Examination of Model data and reports  
on the City of Wichita, *Equus* Beds  
Aquifer and Storage Recovery Project

Case No. 18 WATER 14014

**TECHNICAL ASSESSMENT**

**ASR PERMIT MODIFICATION PROPOSAL  
REVISED MINIMUM INDEX LEVELS & AQUIFER MAINTENANCE CREDITS**

**FIGURE 1**  
**HYDROLOGIC SYSTEM RESPONSE TO CITY PUMPING ASR RECHARGE CREDIT**

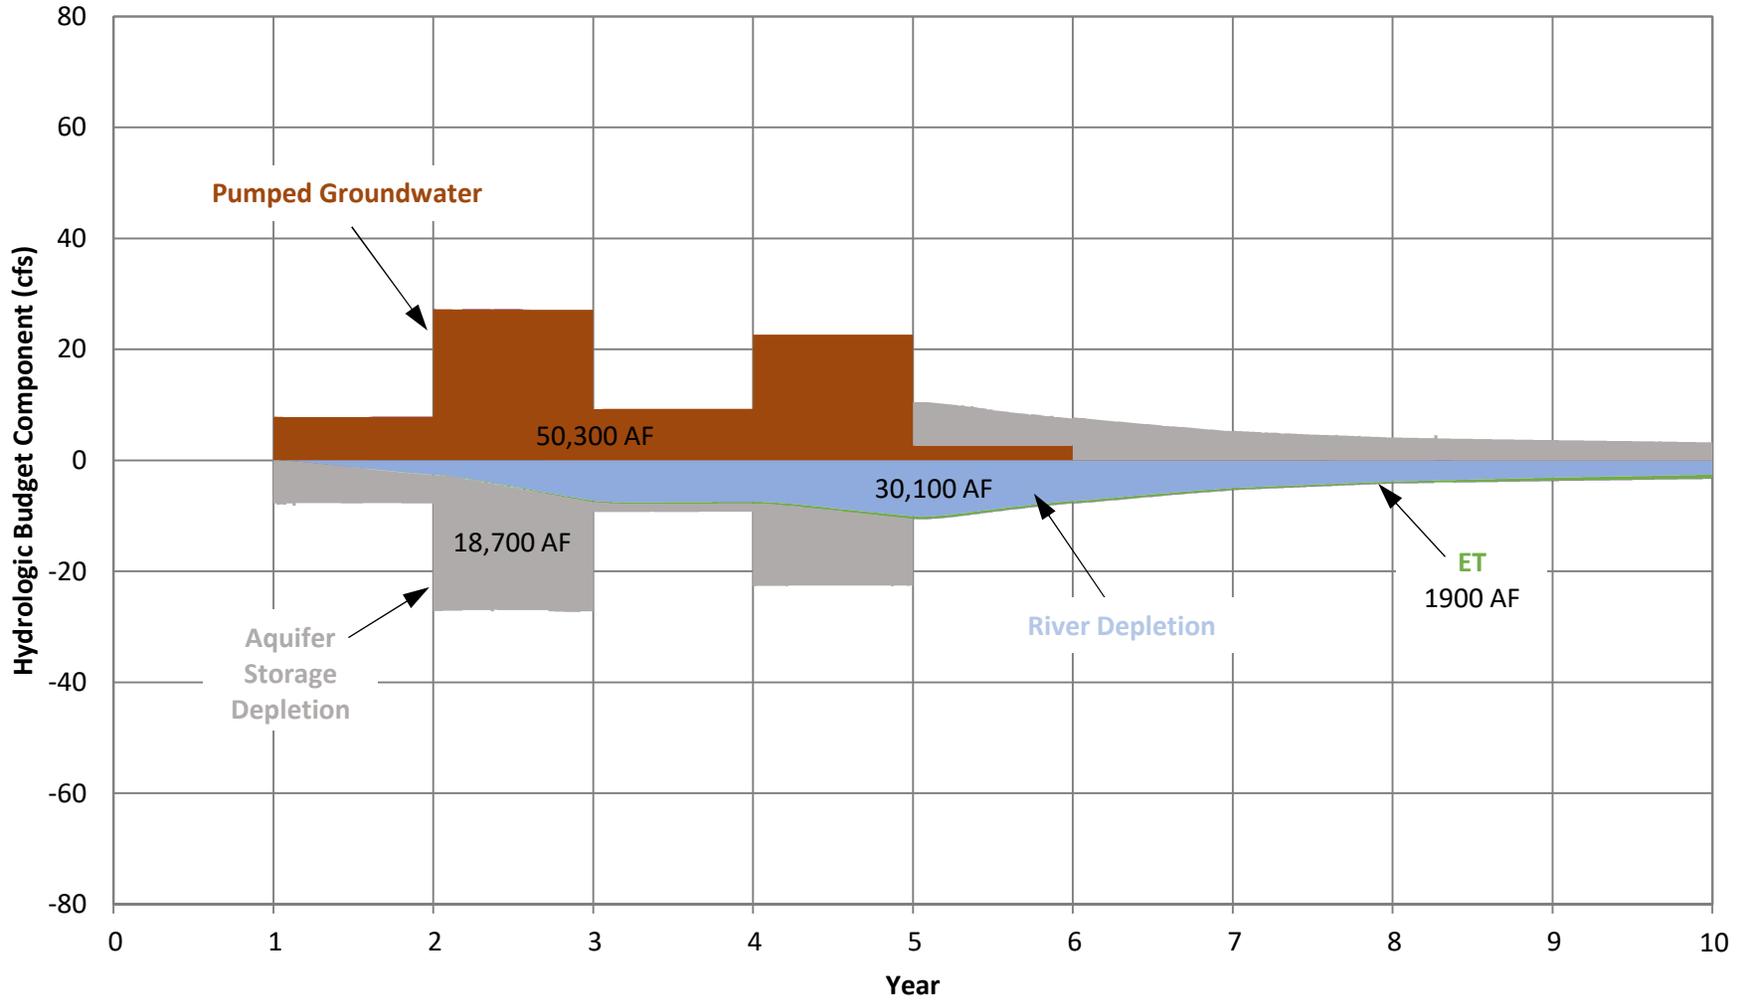
72 The BMcD analysis in the Proposal presents results of the 1% drought simulation in the  
73 context of water-level elevations and percent of saturated thickness of the aquifer. The results are  
74 based on the total City pumping (non-credit and ASR recharge credit) represented in the 1% drought  
75 simulation (Burns & McDonnell, 2018a, Table 2-5). The model has the capability of isolating  
76 hydrologic effects from components of City pumping. For example, the BMcD 1% drought analysis  
77 can be adapted to quantify the hydrologic effect of pumping the ASR recharge credit. **Figure 1**  
78 shows how the hydrologic system responds to City ASR recharge credit pumping in the 1% drought  
79 simulation. Initially, the pumping produces most of the water from aquifer storage, but as pumping  
80 continues, the cone of depression from groundwater pumping induces (depletes) flow from the Little  
81 Arkansas and Arkansas rivers. A notable observation on **Figure 1** is that stream depletion continues

82 to occur for years after groundwater pumping ceases. This lagged depletion response occurs  
83 because, even though pumping has stopped, stream depletion continues to fill in the cone of  
84 depression that was caused when the well was pumping.

**FIGURE 3**  
**HYDROLOGIC SYSTEM RESPONSE TO CITY PUMPING PERMITTED ASR RECHARGE CREDIT (SCENARIO B)**

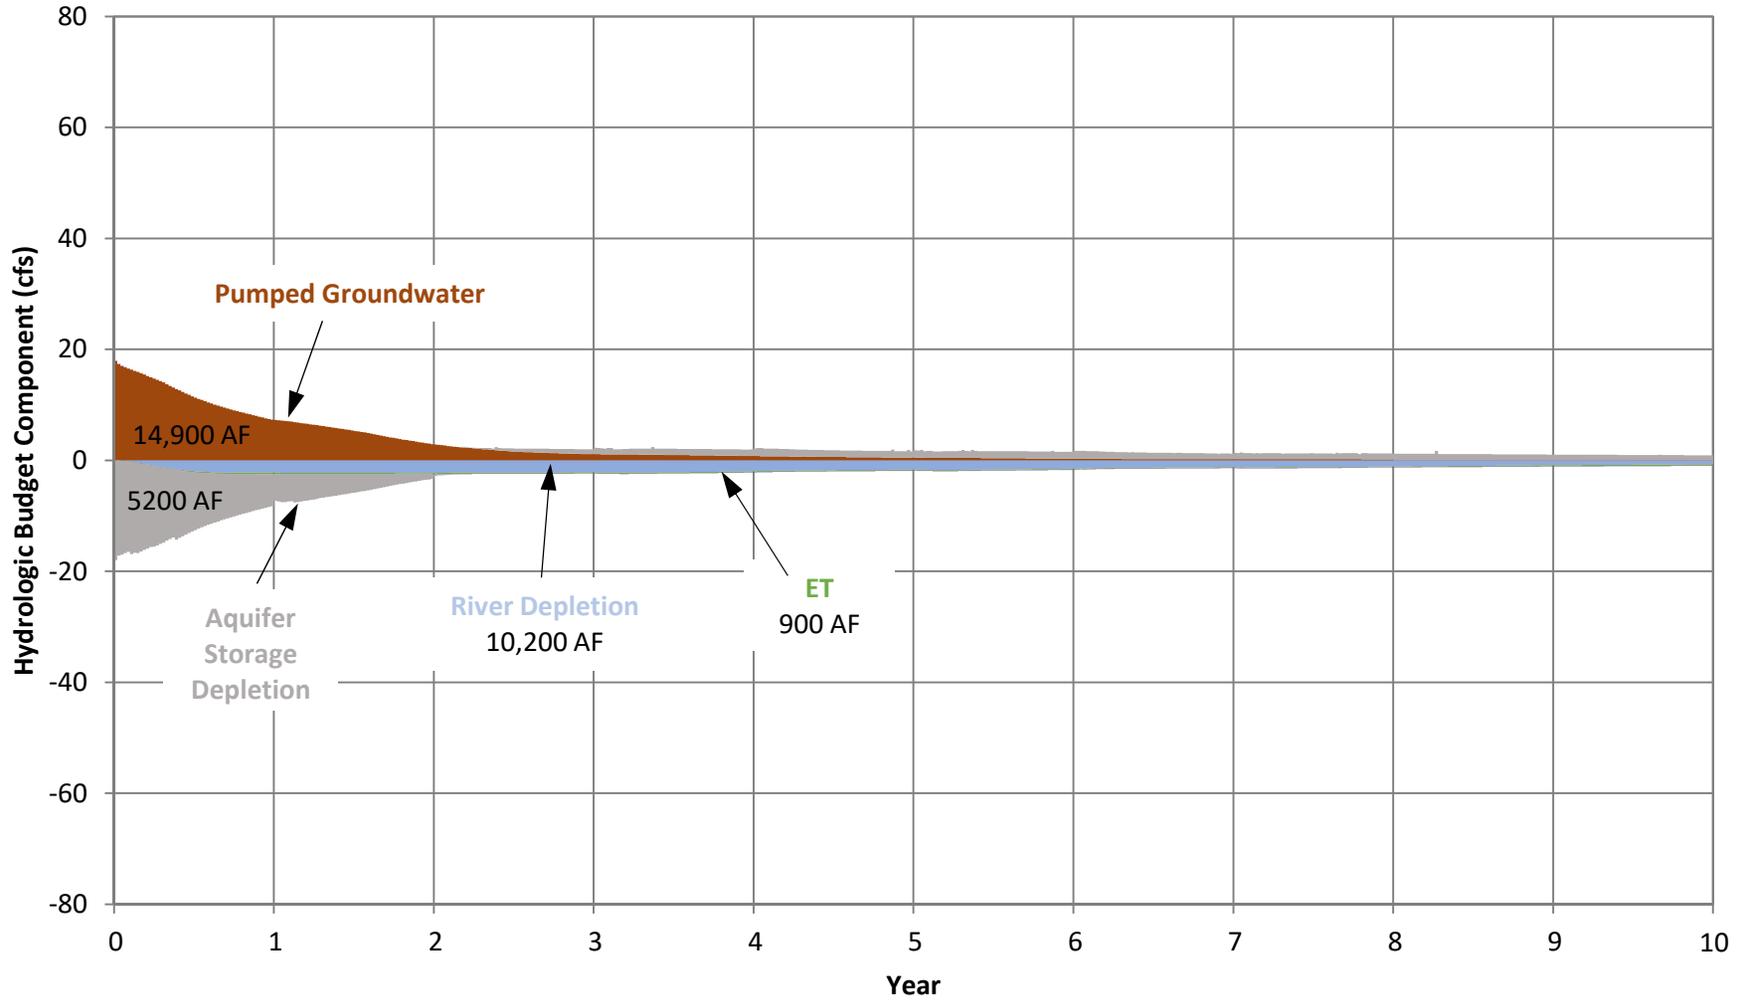
137 The pumping schedule for diverting ASR recharge credit is based on using the model to  
138 solve for the amount of credit water that can be diverted from above the current minimum index  
139 level. The analysis is derived by running the 1% drought scenario with the City goal of diverting  
140 40,000 AF/y and using the MNW-well capability to determine the amount of water remaining  
141 above the current minimum index levels that can also be diverted. That amount of water remaining  
142 is the ASR recharge credit water that can potentially be diverted with the City's existing ASR permit  
143 (subject to also pumping 40,000 AF/y). The analysis allows for isolating the potential ASR recharge  
144 credit water that can be diverted in the 1% drought scenario. **Figure 3** shows the quantity of that  
145 water and the hydrologic system response of pumping it. The total amount water diverted is about

146 14,900 acre feet, which indicates that, if the City prioritizes pumping 40,000 AFY to pumping ASR  
147 recharge credit, much of the water diverted from above the current minimum index level is to satisfy  
148 the goal of diverting 40,000 AF/y.

**FIGURE 4**  
**HYDROLOGIC SYSTEM RESPONSE TO CITY PUMPING PROPOSED ASR RECHARGE CREDIT (SCENARIO C)**

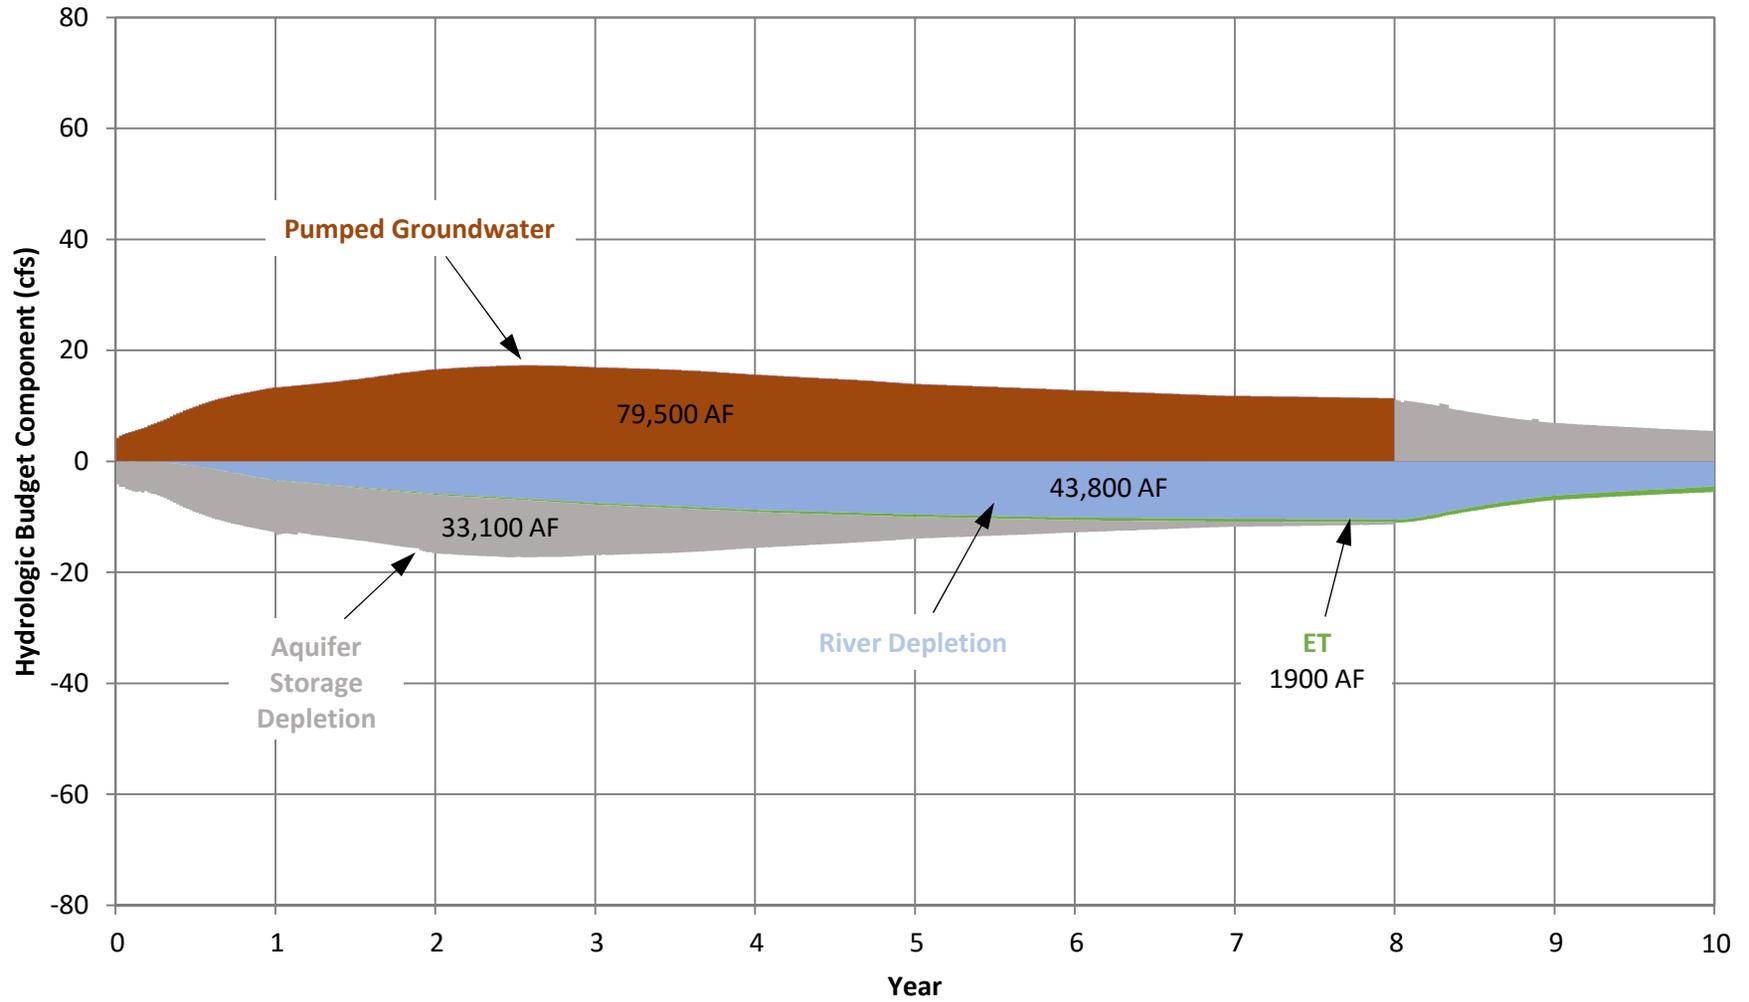
155 drawdown from City pumping occurred to the level of the proposed minimum index level. **Figure 4**  
156 shows the hydrologic system response to that diversion and indicates the amount of ASR recharge  
157 credit water that could produced is 79,500 acre feet, which is in addition to the 14,900 acre feet  
158 produced in Scenario B.

**FIGURE 5**  
**FLOW ON LITTLE ARKANSAS RIVER AT VALLEY CENTER (USGS 07144200)**

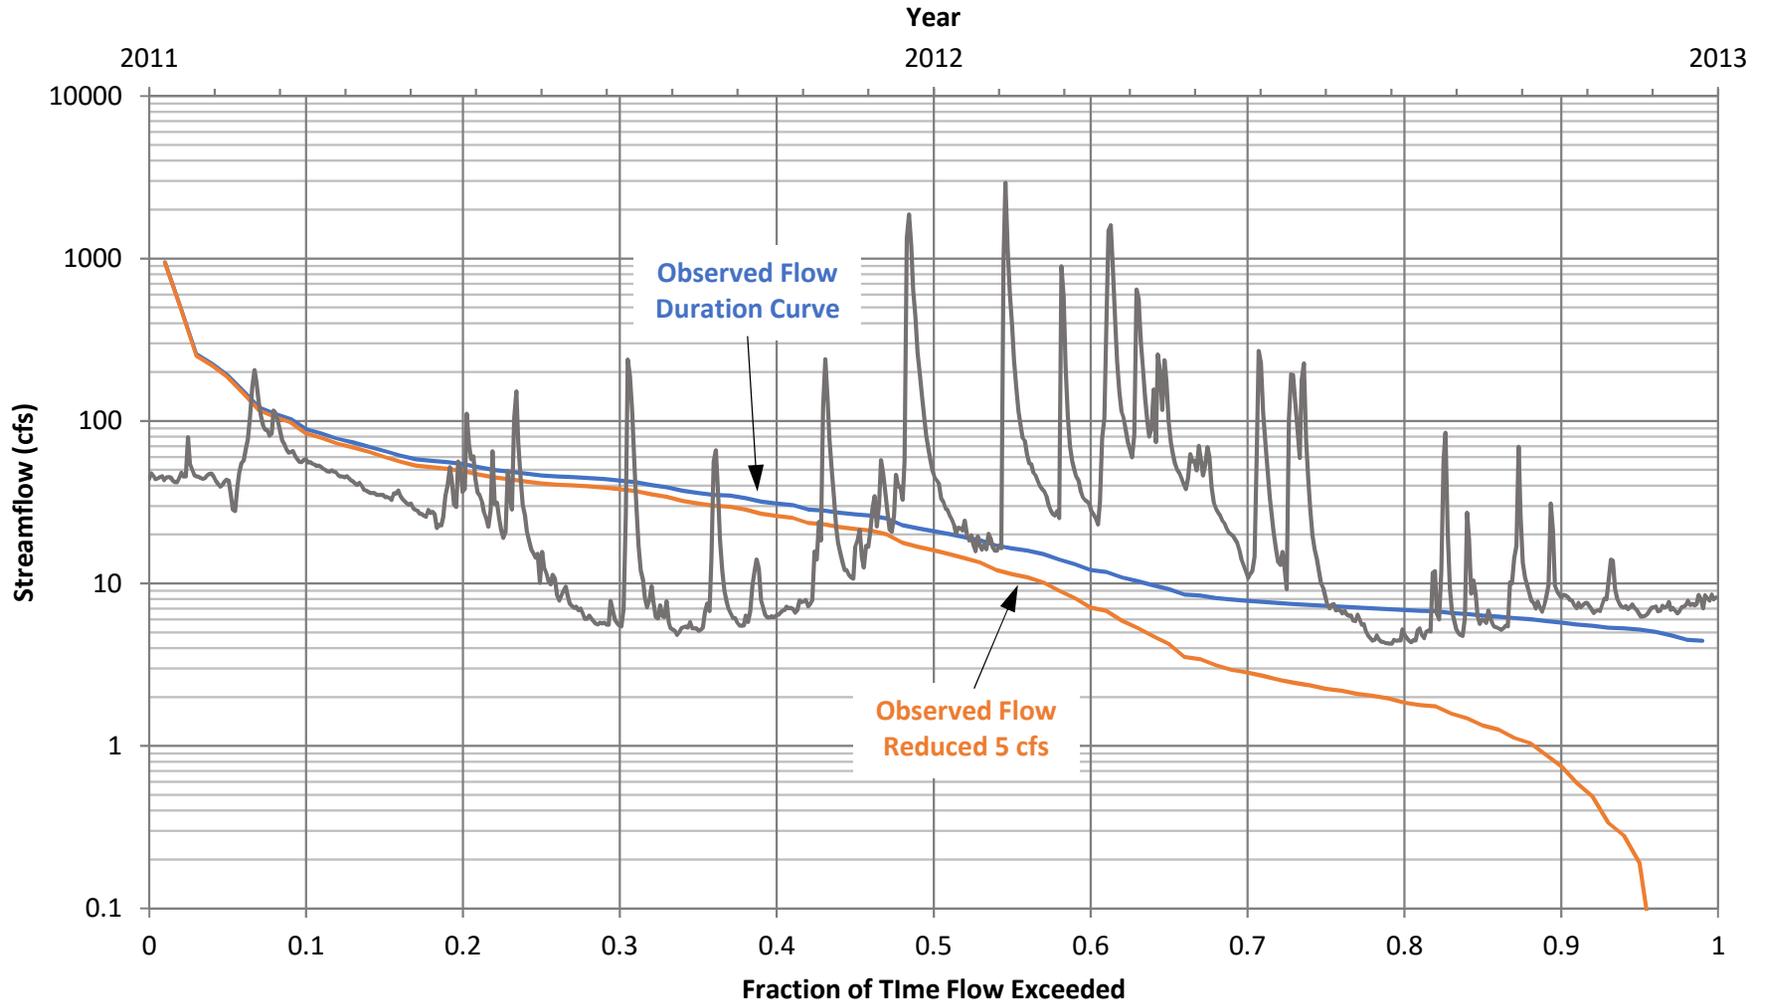
176 The minimum desirable streamflow (MDS) established at the gage on the Little Arkansas at  
177 Valley Center is 20 cfs.<sup>3</sup> **Figure 5** shows a chart of flow at that gage during the two years (2011 and  
178 2012) that characterize the 1% drought scenario. During that time, flow at the gage is below 20 cfs  
179 49 percent of the time. A change in flow of 5 cfs at that gage (assuming about half of the impact  
180 occurs on the Arkansas River) during the drought, would impact MDS flow so that it is less than 20  
181 cfs about 53 percent of the time (**Figure 5**). The percentages translate to about one month of MDS  
182 flow not met due to drawing down water levels from the current minimum index level to the  
183 proposed level.
